Modifications to the Artemis Marine Radar

This document outlines the planned modifications to the Artemis sub-assemblies to assist with an application for a permissive change.

1. Antenna

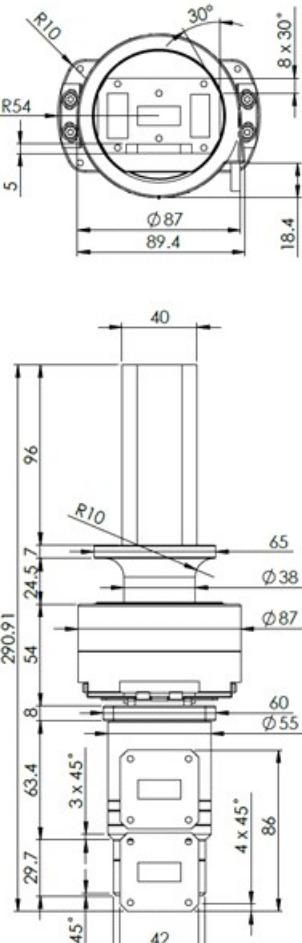
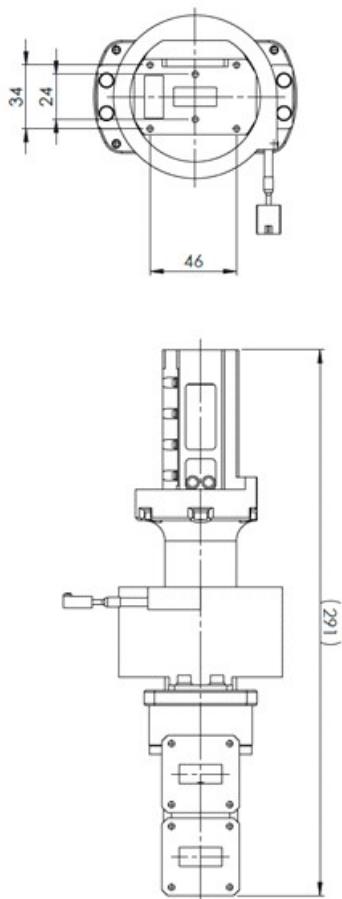
Reason for change of 20-0214-4 to 21-0530

Improvements to components and simplification of manufacture/assembly.

3. Flange and Rotary Joint and Encoder Assembly

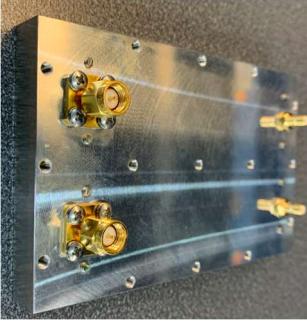
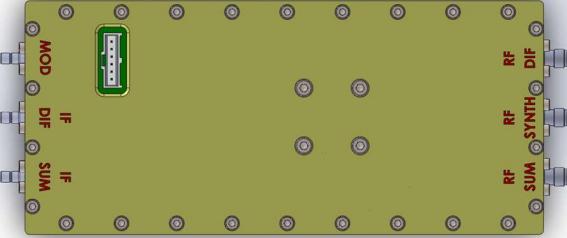
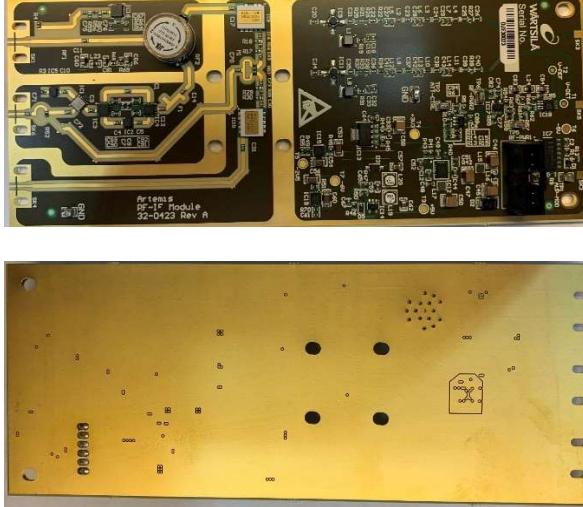
Reason for Change of 21-0240 to 21-0559.

Improvements to components and simplification of manufacture and assembly. All interfaces and fixings are identical

6. Input Pre-Amplifier to Solid state RF-IF Assembly

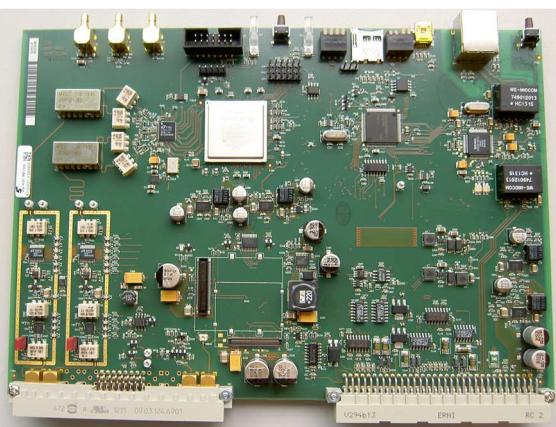
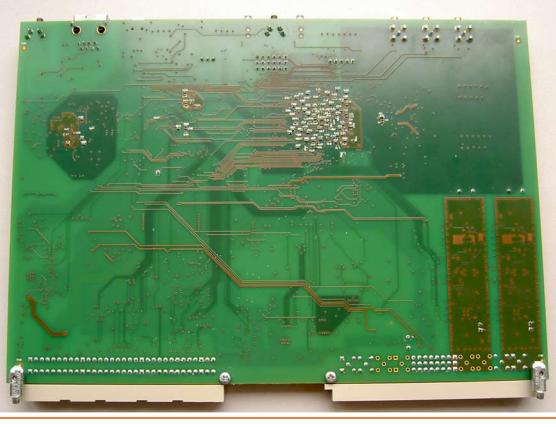
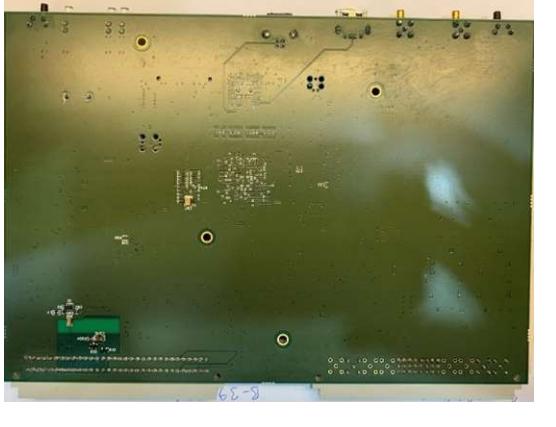
Reason for change

The 21-0433-3 Input pre-amplifier, which consists of waveguide circuitry has potential cost, supply and performance issues. Improvements can be gained from a solid-state electronics version. The assembly 21-0537 also has the benefit of amplifiers that have lower noise performance when compared to the waveguide circuitry.

11. General Assembly: Proposed Modification

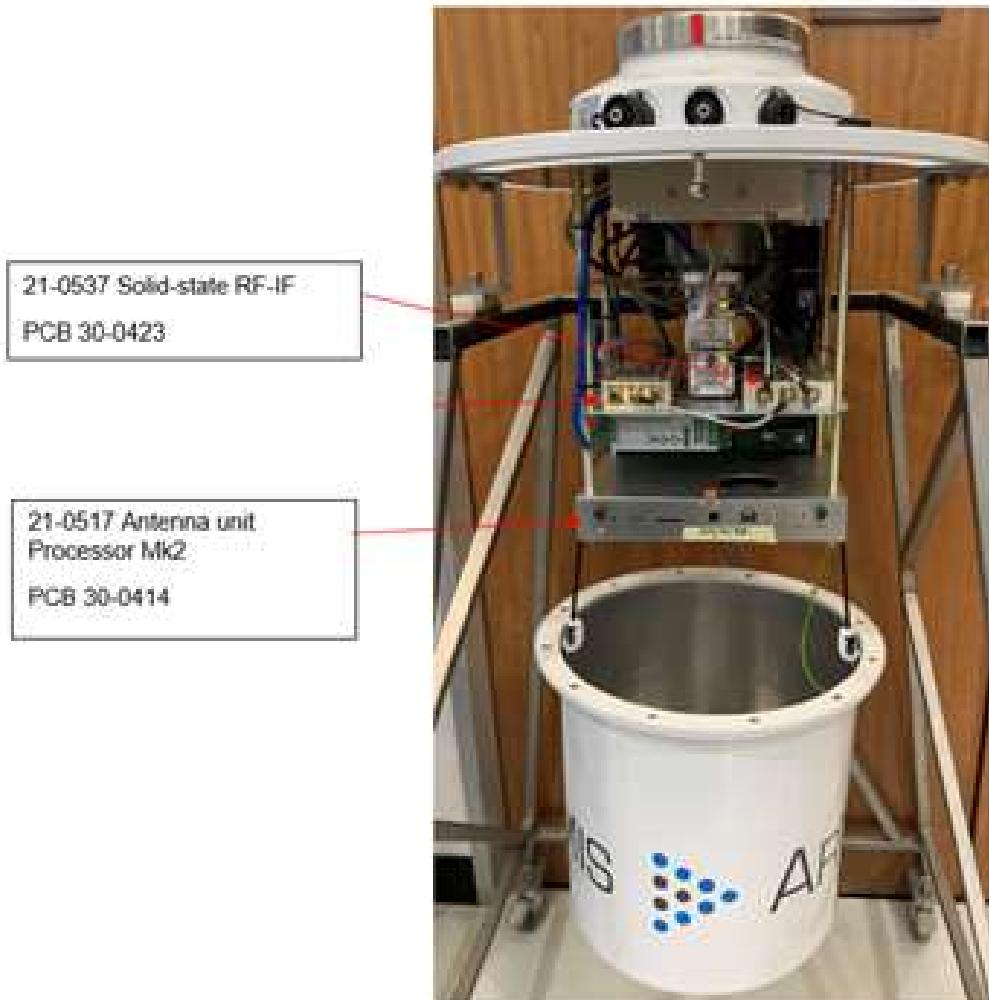
The General Arrangement with the modified sub-assemblies are shown in the picture below.
